A 545025_ Percolation Information- 12671 Lime Kiln Road-Lot 2

RE: 12671 Lime Kiln Rd.
Fulton, MD 20759
"OSDS Plan"

I have reviewed the Onsite Sewage Disposal System Plan and here are my comments.

RE: 12671 Lime Kiln Rd.
Fulton, MD 20759
"OSDS Plan"

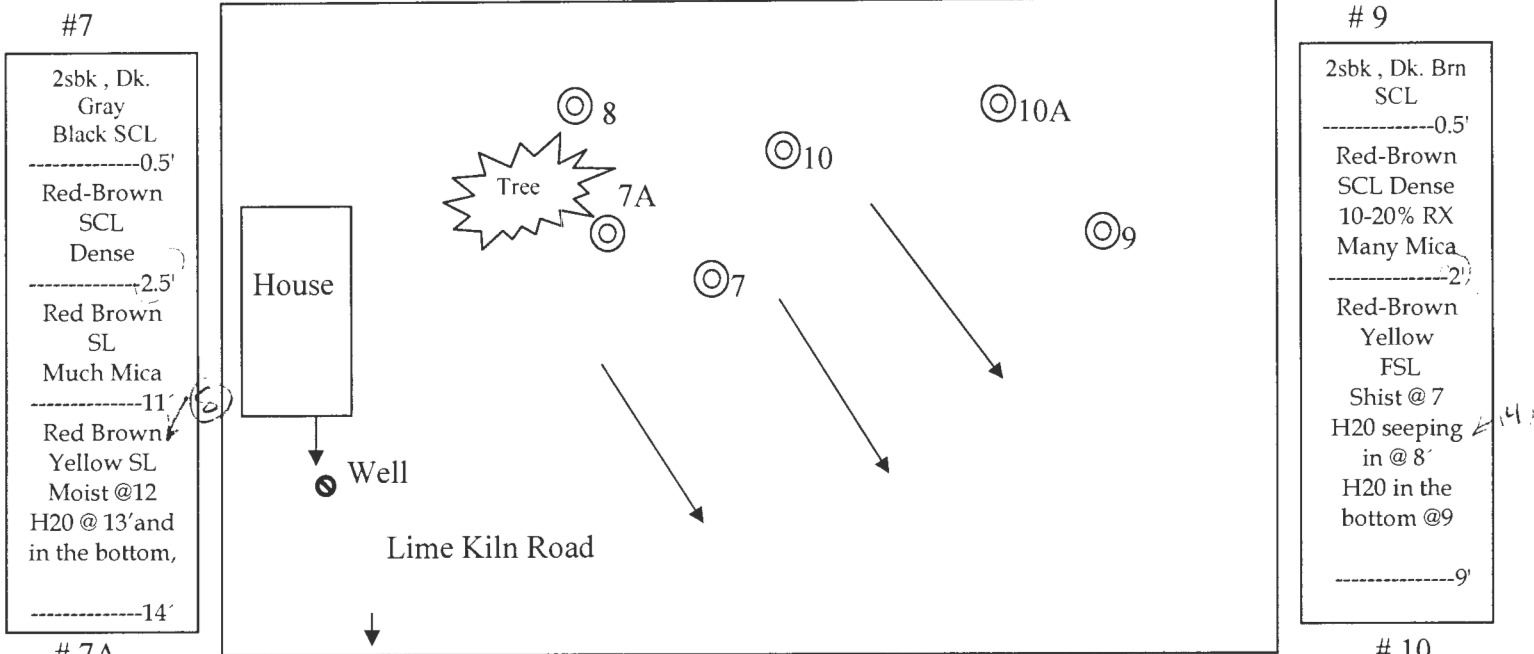
Remarks: Perc holes must be surveyed on Percolation _Certification Plan.
 Area was modified to get percolation testing area. Several proposed percs were located in a swale. Cannot use Percolation hole #9 due high water table. Well must be abandoned to established area. New well must be

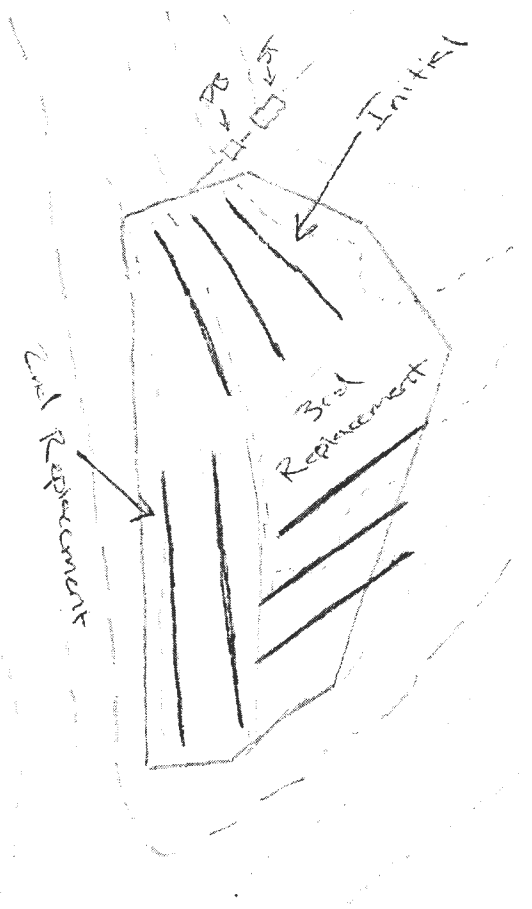
- The 2" perforated pipe shown on the "Initial Trench Detail" needs to be changed to a 4" perforated pipe.
- Individual trenches cannot contain T bends in them. Bends of 45° or less could be acceptable.
